HISTORIC AND DESIGN REVIEW COMMISSION

HDRC CASE NO: 2019-682
ADDRESS: 1500 N ST MARYS
LEGAL DESCRIPTION: NCB 997 BLK G LOT 1A 2A B2
ZONING: FBZ T5-1, RIO-2
CITY COUNCIL DIST.: 1
APPLICANT: Jennifer Gonzalez/ACG ST MARYS PLACE LOFTS GP LLC
OWNER: Jennifer Gonzalez/ACG ST MARYS PLACE LOFTS GP LLC
TYPE OF WORK: Amendment to a previously approved design regarding materials and architectural elements
APPLICATION RECEIVED: November 07, 2019
60-DAY REVIEW: January 06, 2019
CASE MANAGER: Edward Hall
REQUEST:

The applicant is requesting a Certificate of Appropriateness for approval to modify the previously approved design. Within this request, the applicant has proposed to:

1 JONES ELEVATION
SCALE: 1/8"=1'-0"

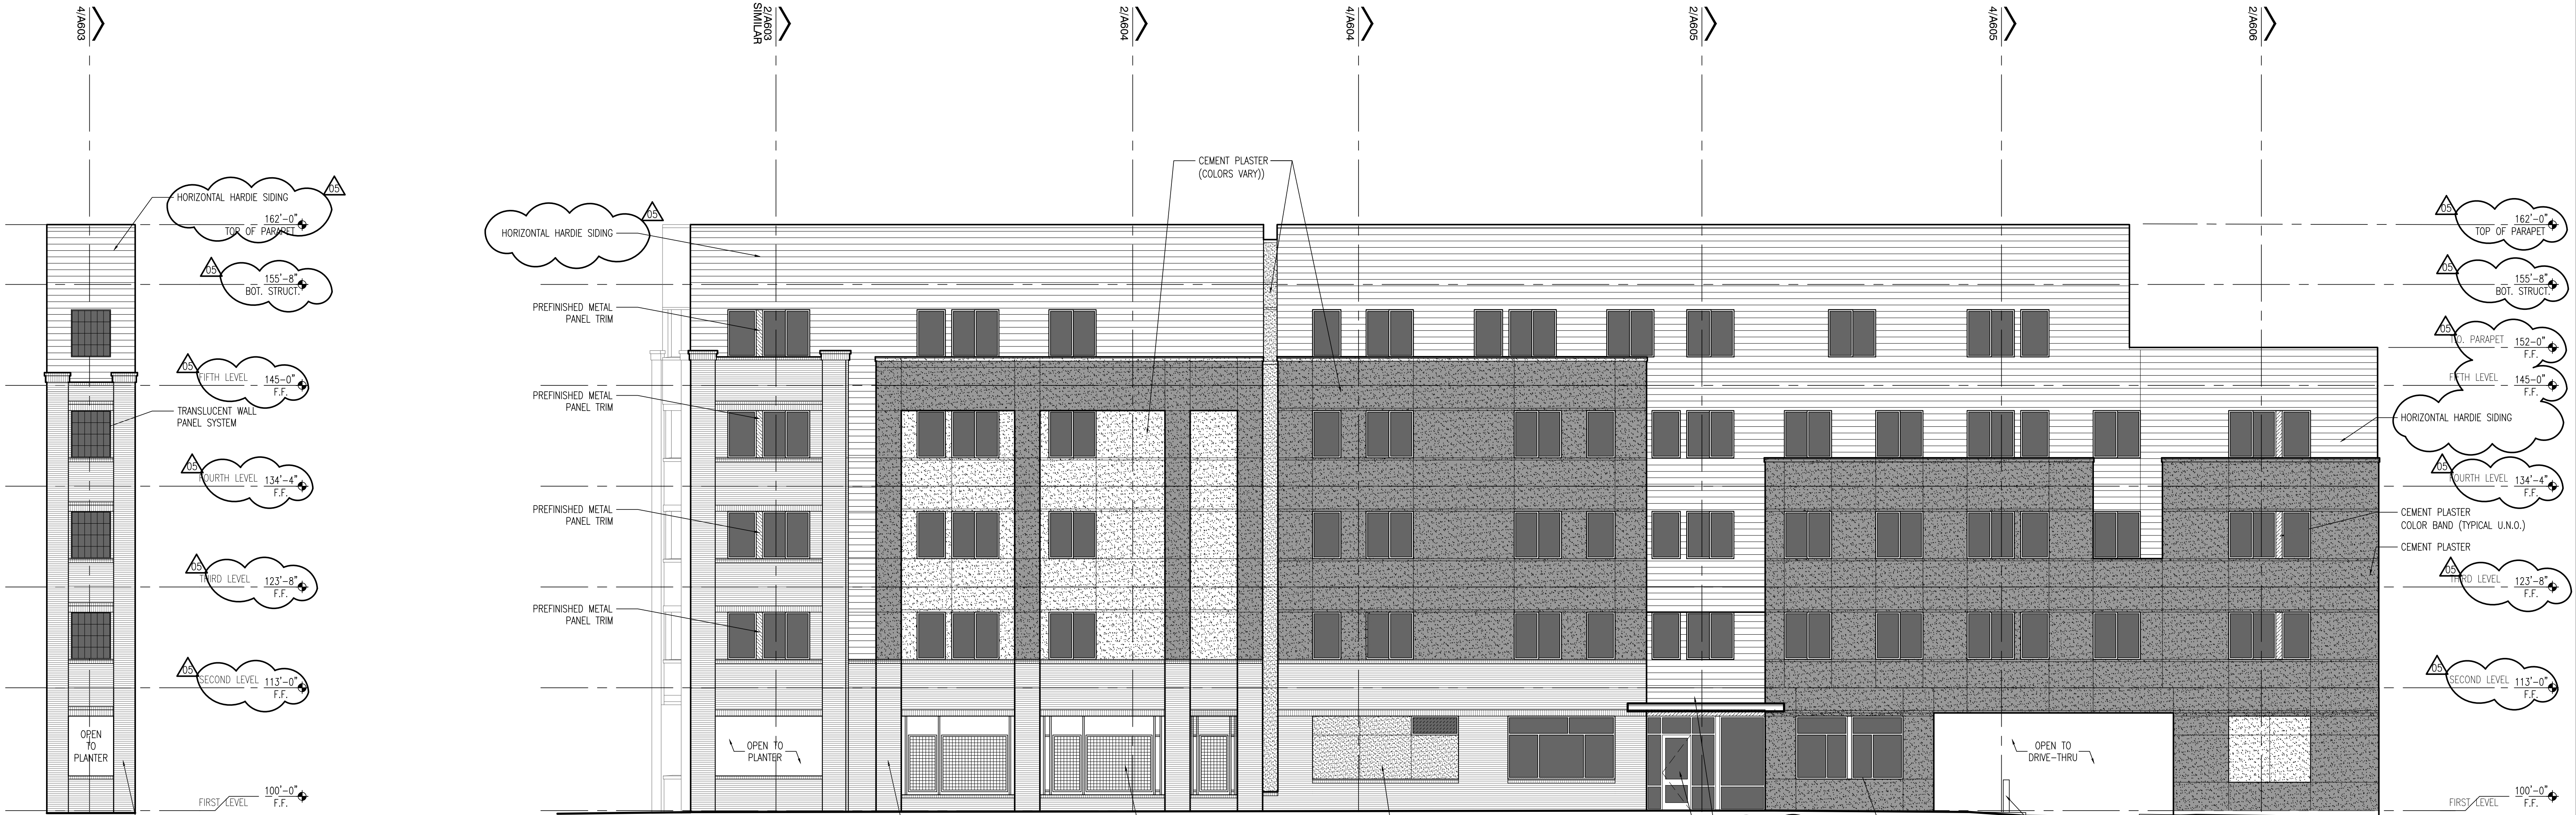
- e. MATERIALS – The UDC Section 35-674(d) notes that indigenous materials and traditional materials should be used for primary wall surfaces. Additionally, the UDC notes that a minimum of seventy-five (75) percent of walls shall be comprised of the following materials: modular masonry, stucco and painted concrete, painted or stained wood, and other materials that convey the texture, scale and finish similar to traditional building materials. Staff finds the use of stucco to be appropriate; however, staff finds that the previously approved color palette should remain, or similar colors should be used on various façade planes to provide visual depth to each façade. In regards to the proposed Hardie siding, staff finds the use of Hardie to be appropriate; however, staff finds that the applicant should provide additional information to staff regarding the exposure, finish, and trim detailing for the proposed siding. Staff finds that an exposure of no larger than eight (8) inches should be used, that the proposed Hardie should feature a smooth finish, that the Hardie be painted a dark color and that the applicant explore contemporary installation profiles.

- f. WINDOW PROFILES– The applicant has proposed to modify the previously approved window profiles from windows that featured a separating rail to create a transom element to windows that are shorter in profile with no transom element. Staff finds the modification to be consistent with the UDC; however, the applicant should provide additional information, such as head and sill details as was previously submitted. Additionally, per the UDC, windows are to be recessed at least two (2) inches within walls. This applicant is responsible for complying with this requirement. Staff also finds that dark colored window frames should be installed. White should not be used.

- g. **TOWER ELEMENT / ARCHITECTURAL FOCAL POINT** – The applicant has proposed to eliminate the tower element that was proposed at the corner of N St Mary’s and Jones Avenue. The UDC Section 35-672(c)(1), notes that an architectural focal point is to be incorporated into the design when a property is situated in such a manner as to appear as the terminus at the end of the street. An architectural feature will be considered to be a focal point through any of the following methods, but not limited to: additional height, creation of a tower, variation in roof shape, change of color or materials or the addition of a design enhancement feature. Staff finds that the applicant should incorporate an architectural focal point that is consistent with the UDC.

- h. **STREET & FAÇADE CANOPIES** – The applicant has proposed to eliminate the previously proposed street and façade canopies. Previously, the canopies were incorporated into the design to provide a human scale and the street level, and the provide separation between the base, mid-section, and building cap; however, staff finds that the modified design still provided a human scale and a separation between the base, mid-section and building cap. Staff finds the proposed removal of street and façade canopies to be appropriate, provided that architectural detail can be introduced which maintains interest at the pedestrian level.

- i. **CHANGE IN MATERIALS** - That the previously-approved color palette remain, or similar colors be used on various façade planes to provide visual depth and separation to each façade section as noted in finding e. The applicant must also provide additional information to staff regarding the exposure, finish, and trim detailing for the proposed siding. Staff finds that an exposure of no larger than eight (8) inches should be used, that the proposed Hardie should feature a smooth finish, that the Hardie be painted a dark color, and that the applicant explore contemporary installation profiles.

ORIGINAL DESIGN

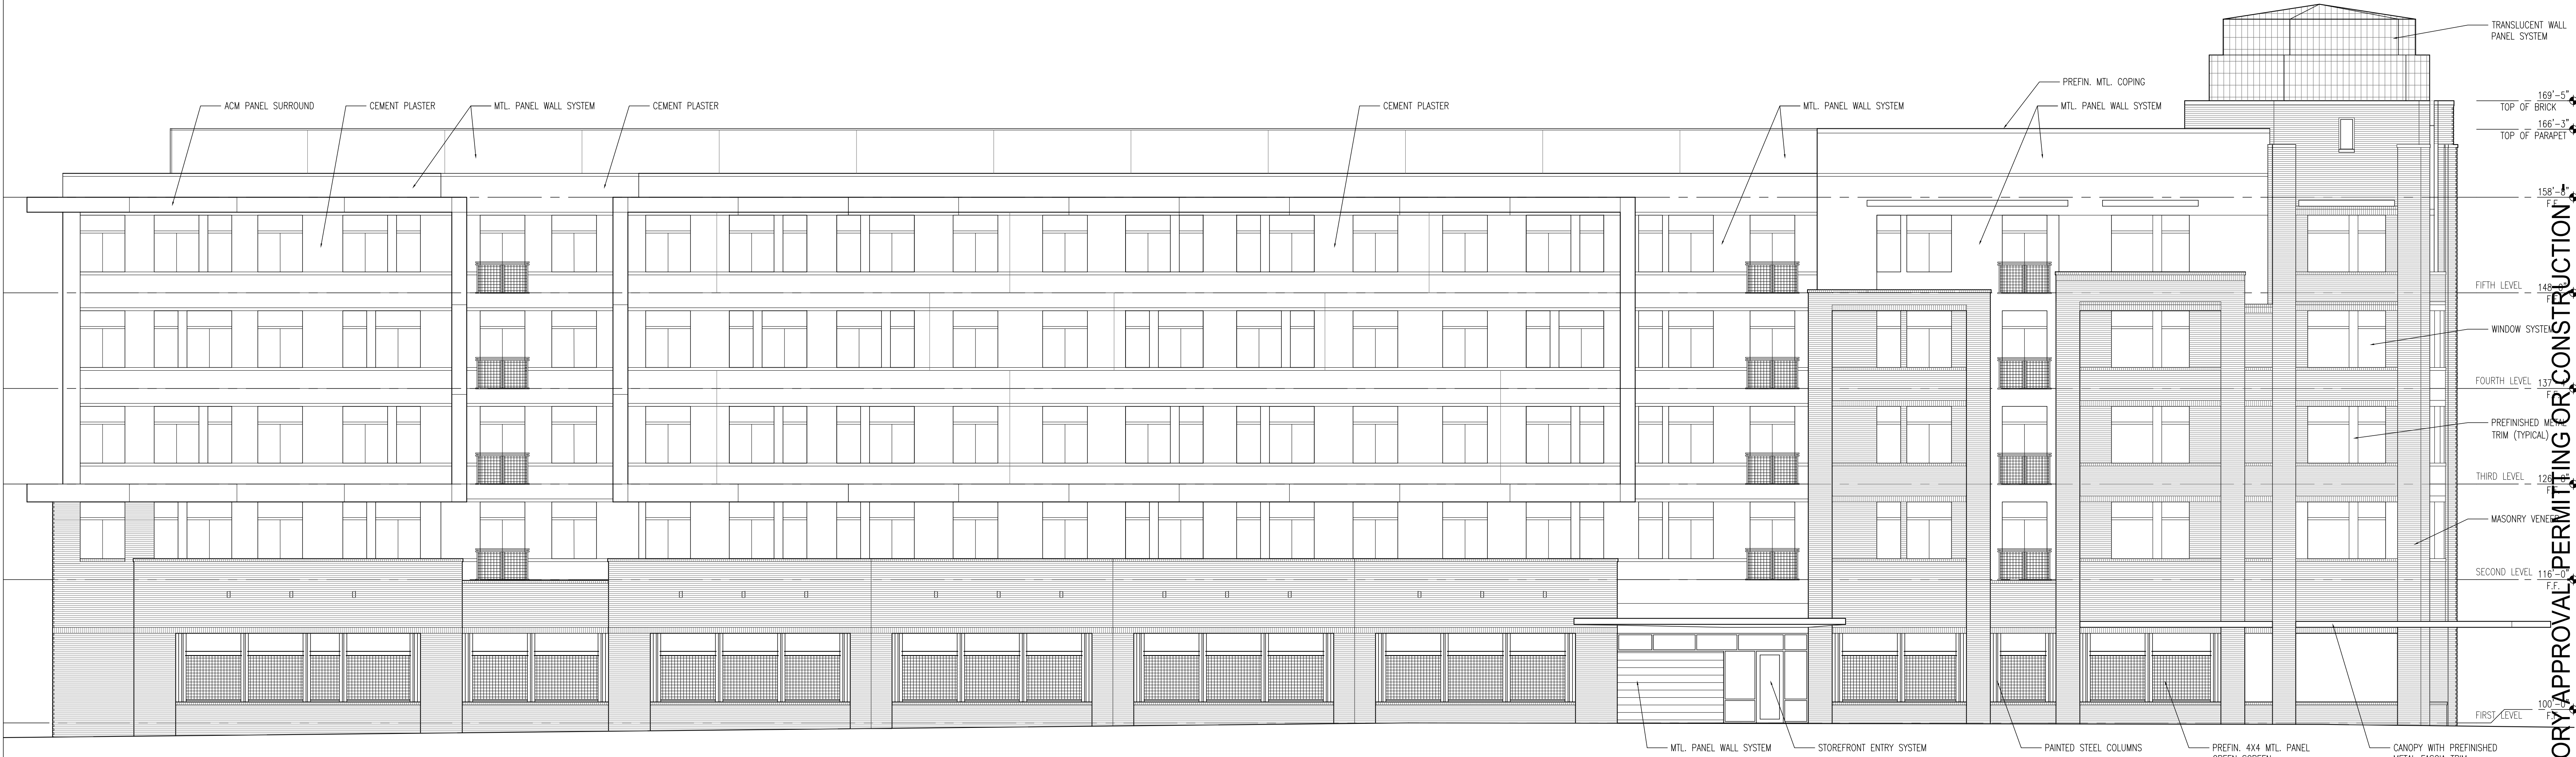
- b. At this time, the applicant is requesting to modify the materials of the previously approved design. The overall massing, height and footprint of the proposed new construction will remain unmodified.
